**SERVICE BULLETIN**

**APPLICABILITY:** 2015-19 Legacy and Outback 2.5L **NUMBER:** 07-153-19  
**SUBJECT:** Ignition Coil Cap Now Available as Service Part **DATE:** 05/07/19

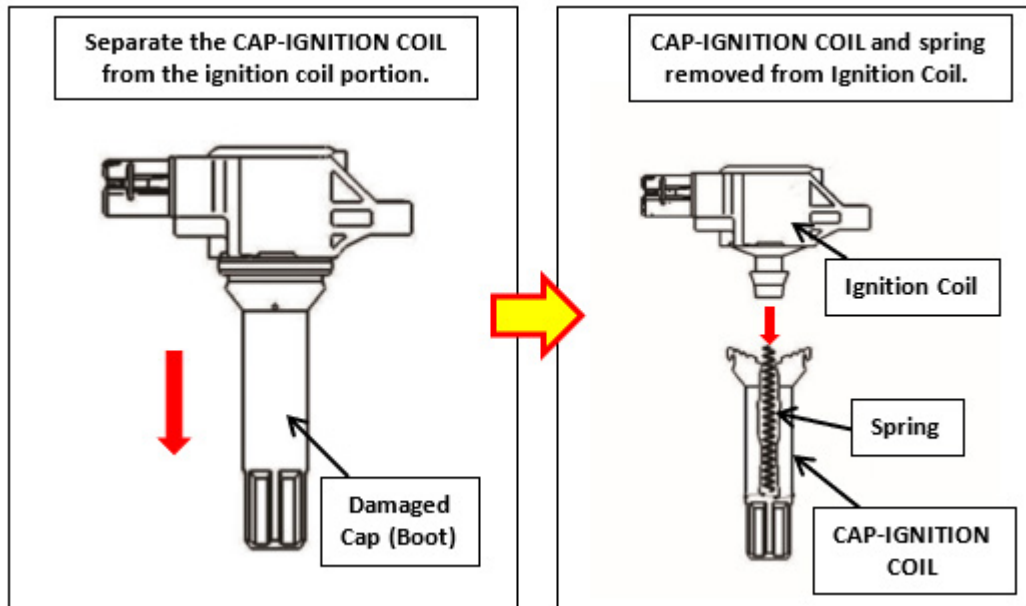
This service bulletin announces availability of the cap portion (a.k.a. spark plug boot) as a service part separate from the complete ignition coil assembly. If the cap portion as shown in the illustrations below is damaged during removal or replacement, it is no longer necessary to replace the complete ignition coil assembly.

The part number for the new CAP- IGNITION COIL is **22489AA040**.
